Eureka Airport

Standards Review
Nonstandard Conditions & Notes

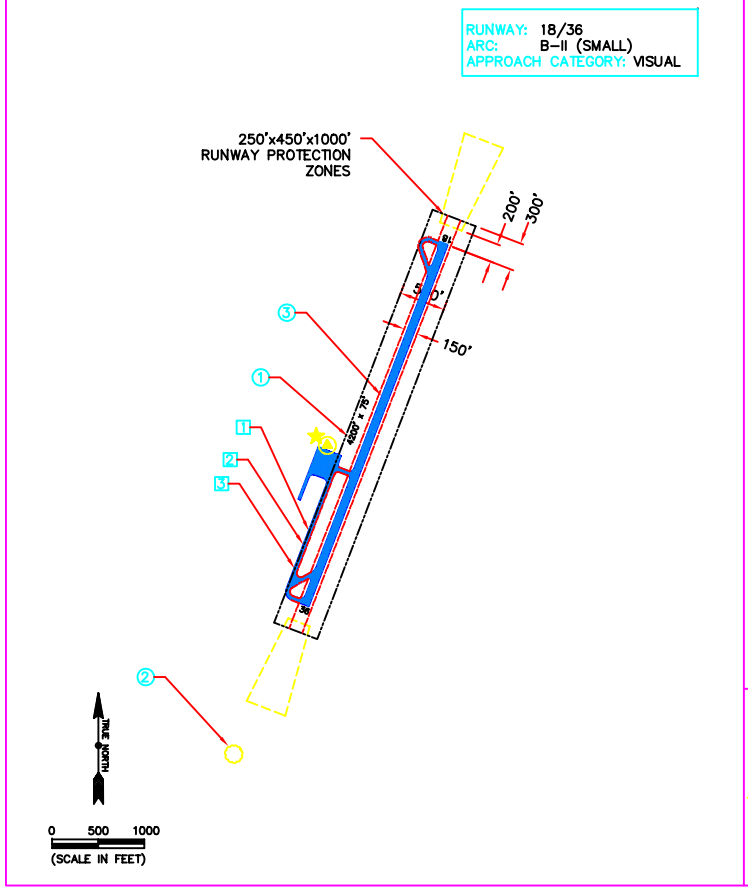
Runway 18 / 36

1. RUNWAY LENGTH RECOMMENDED TO MEET 100% OF SMALL AIRCRAFT NEEDS (4,680 FT).
2. TREE PENETRATES 20:1 APPROACH SLOPE.
3. PAVEMENT EDGES ARE FLUSH.

Taxiways & Aprons

1. 25 FT. WIDE TAXIWAY SHOULD BE 35 FT. WIDE.
2. NO TAXIWAY CENTERLINE STRIPE.
3. PAVEMENT EDGES ARE FLUSH.
